D206-642-341BL
Job Sheet 167820-L

Part Name: Replacement Skidtube (Fits LH or RH)

DRAWING NO. D2650	TITLE 206/407 SKIDTUBE ASSEMBLIES	REV. F	DART AEROSPACE LTD ENGINEERING ORDER		D.E.O. NO. D2650-F-1	SHEET NO. SHEET 1 OF 1	SCALE NTS
DRAWN <i>[Signature]</i>	CHECKED A.P.	MFG. APPR. <i>[Signature]</i>	APPROVED <i>[Signature]</i>		DE APPR. <i>[Signature]</i>		
DATE 12.10.12	DATE 12.10.22	DATE 12.10.22	DATE 12.10.22		DATE 12.10.22

CHANGE C'BORED WELDED CROSSBOLT SPACERS TO SWAGED SPACERS

DETAIL G

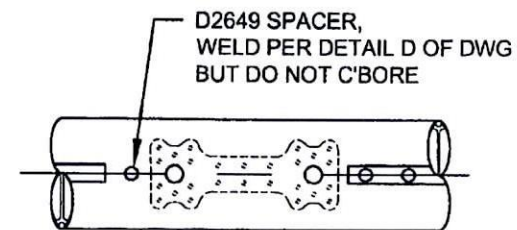
ADD DETAIL G BELOW, WHICH IS THE SAME SECTION VIEW AS DETAIL D OF DWG.

FOR Ø0.375 HOLES ONLY
FOR HOLES THAT ARE CURRENTLY C'BORED ONLY
NOT TO SCALE

AFTER DRILLING AND BENDING ASSEMBLY
PERFORM THE FOLLOWING FOR Ø0.375 HOLES THAT ARE
CURRENTLY C'BORED:

1. INSERT D4720-1 SPACER, 16 PL (-1) OR 17 PL (-3)
OR 19 PL (-5) OR 23 PL (-7)
2. SWAGE TO Ø0.313 X 0.75 DP PER QSI 002
3. TRIM / GRIND FLUSH PER QSI 002

DETAIL B

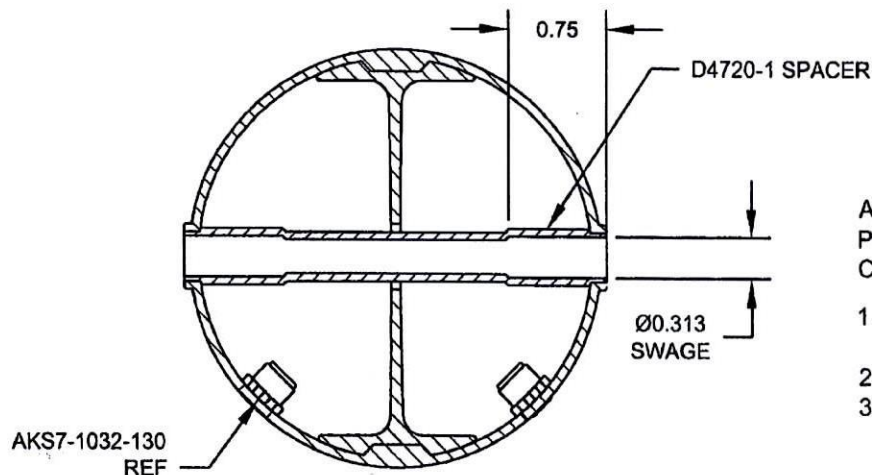
C'BORED HOLES ARE **NOW SWAGED** PER DETAIL G BELOW. FOR THE Ø0.375 HOLE THAT IS NOT C'BORED, WELD PER DETAIL D OF DWG (SEE AMENDED DETAIL B FOR REFERENCE).

AMENDMENT TO DETAIL B
NOT TO SCALE
